SERVICE BULLETIN

SB18-0002

Subject: CRM_48(-XX) Caster Rail Substitution of 3A6717G01, 3A6869-01 and 3A8734-01

CRM_48(-xx)

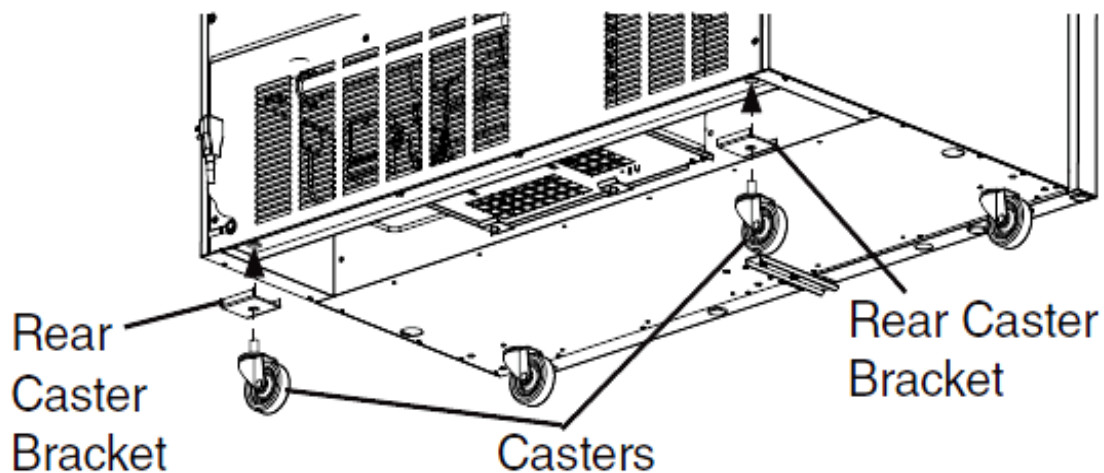
The CRMR48 caster rail design has been changed. All previous versions are no longer available and will sub to the parts shown below.

See the diagram below for installation of the Rear caster brackets.

To replace please order the following:

- 3A8956-01 Caster rail (Qty. 1)
- 3A8957-01 Rear caster bracket (Qty. 2)
